March 22, 2007

RE: 233 Taft Avenue, corner of Robin Street – 272-N- 61 to 67 – R-3 Zone -
determination

Marge Schmuckal
Zoning Administrator

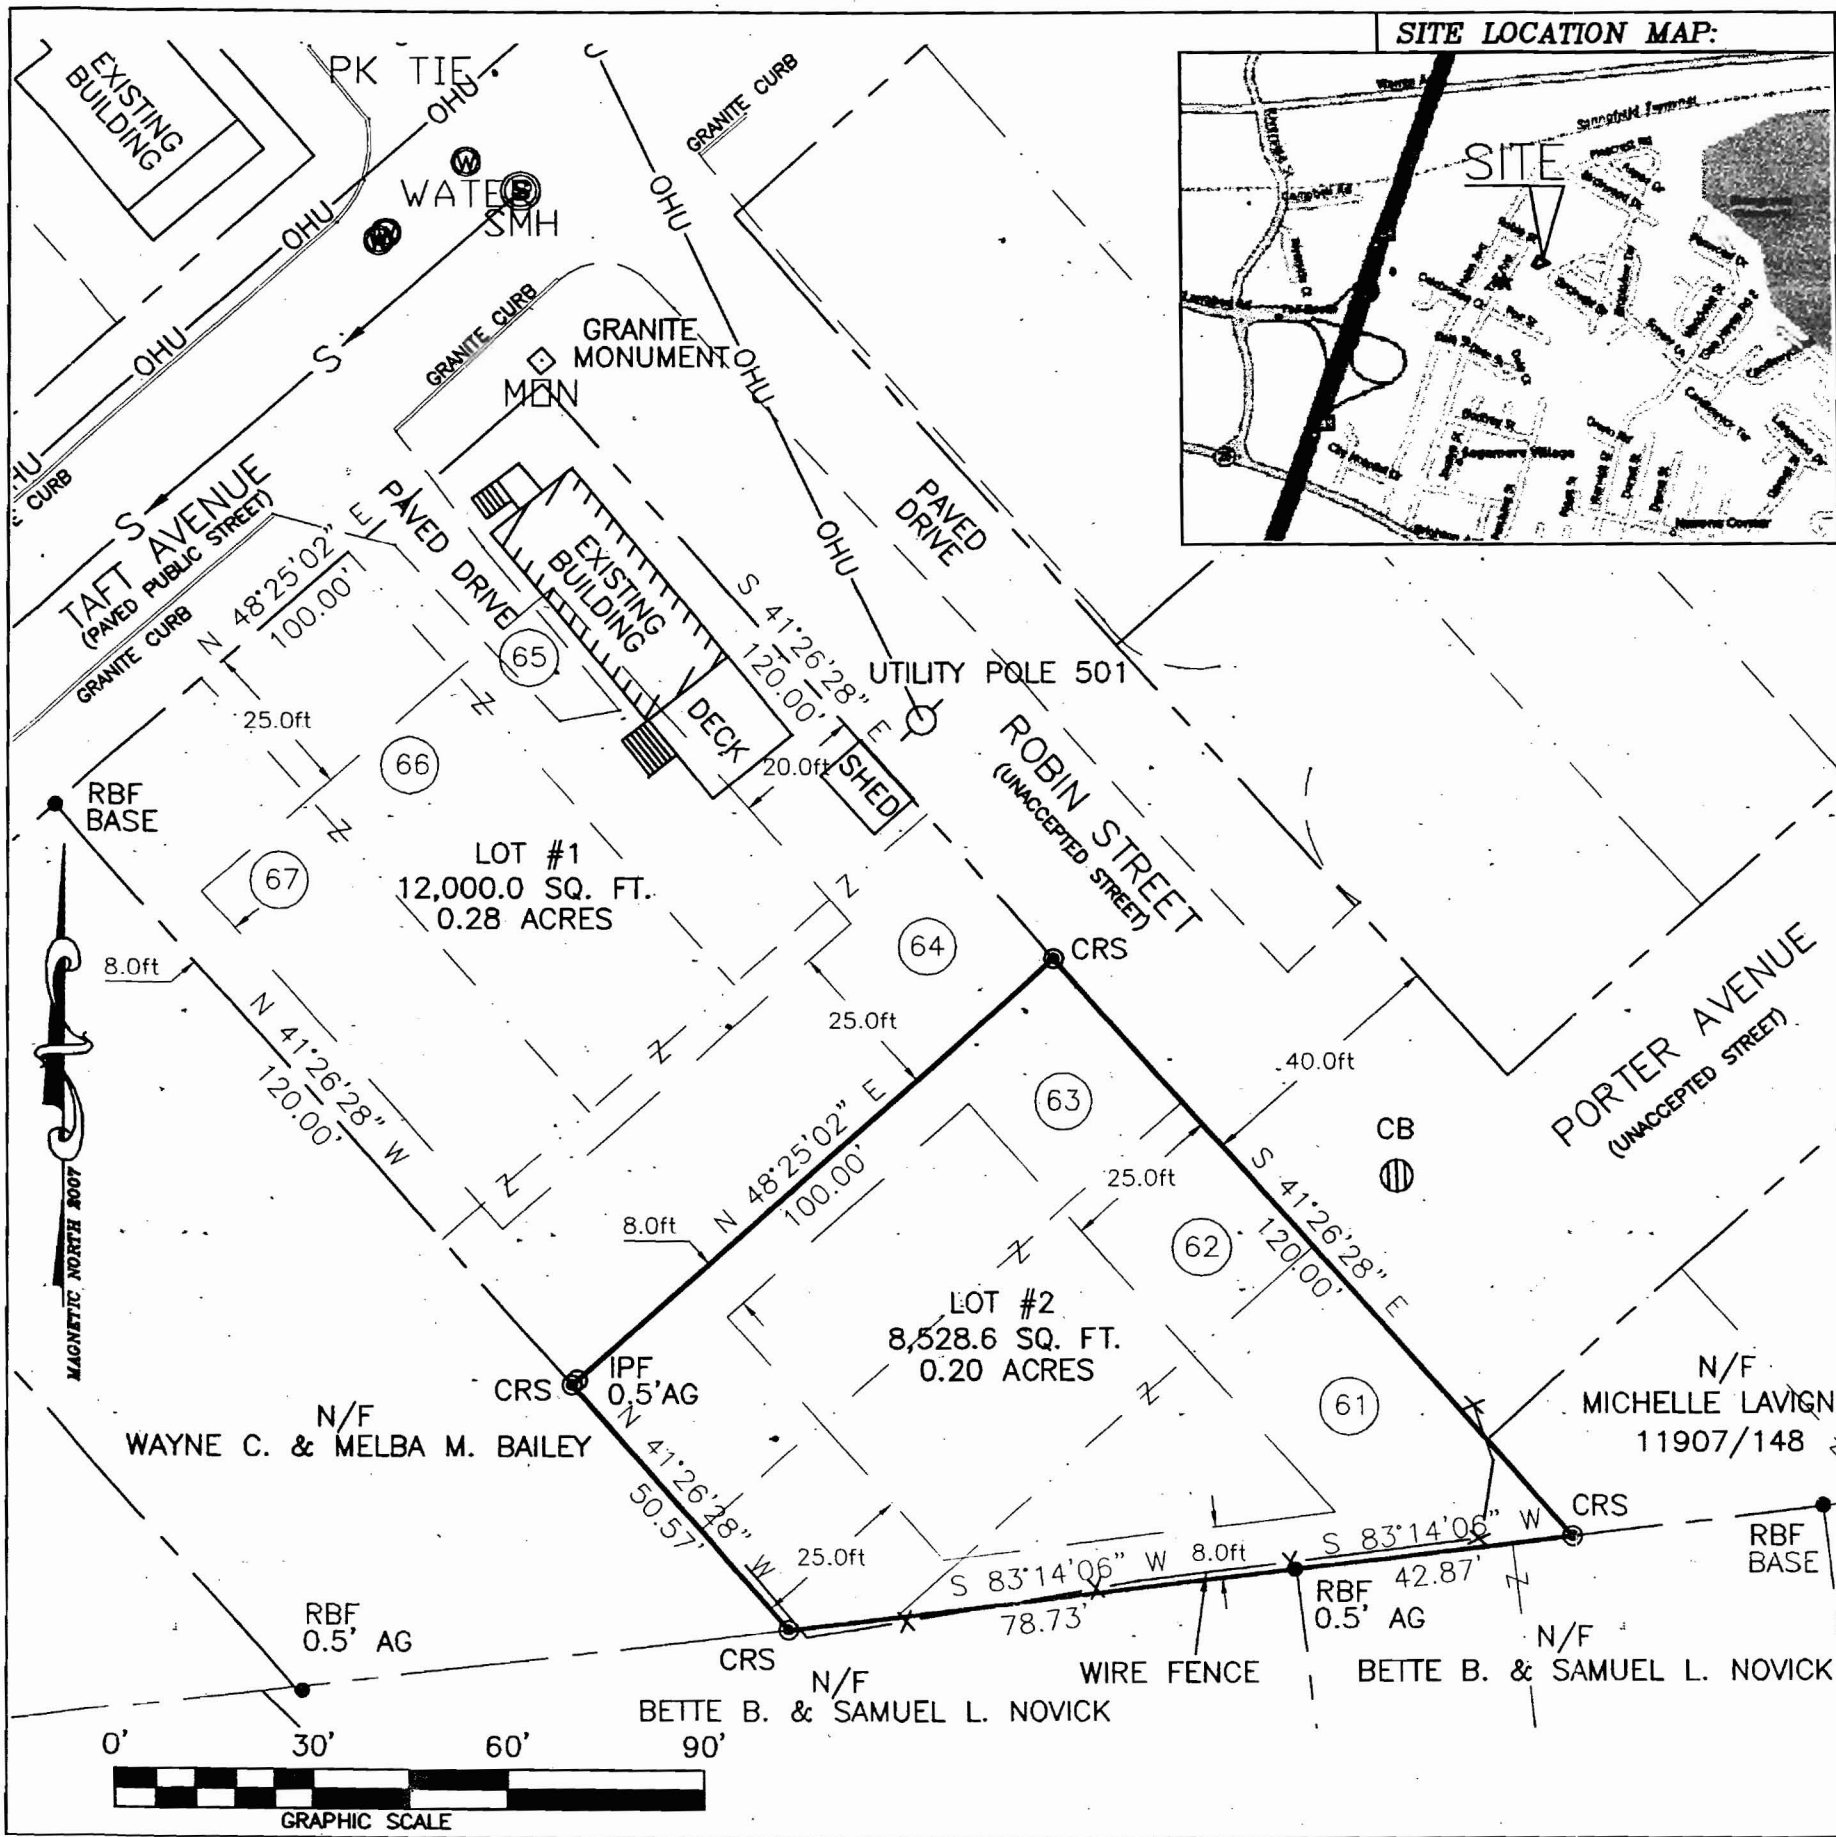
It is noted that the first lot, with the existing single family dwelling, has an 8' x 12' shed that abuts directly along Robin Street. A research of our files shows that the shed has not been permitted and is not meeting current setbacks. This shed must be permitted and moved to meet the current R-3 zone requirements prior to finalizing the proposed lot division.

I am cautioning the applicant concerning the area of the building envelope that is depicted on the survey plans. This envelope can be deceiving to a future owner or developer. First of all, the side setbacks are showing a single story dwelling, not a two story dwelling. I am also bringing attention to the rear setbacks that are shown on the plan. Setbacks are determined by the orientation of a principle structure. Once the structure is shown on the plan, measurements are taken from the placement of the structure. If the back edge of a structure is near the property line that is on an angle along the southeastern line of the property, the 25 foot rear property line may not be met.

Once the detached shed has been legally permitted, both lots shown on the submitted survey will be meeting the underlying R-3 Zone requirements. The newly created vacant lot meets the minimum lot size, street frontage and lot width. Please be aware that there is a requirement in the Land Use Zoning Ordinance (section 14-403) that states: “For a lot abutting any portion of a street which is unimproved or improved but not permanently
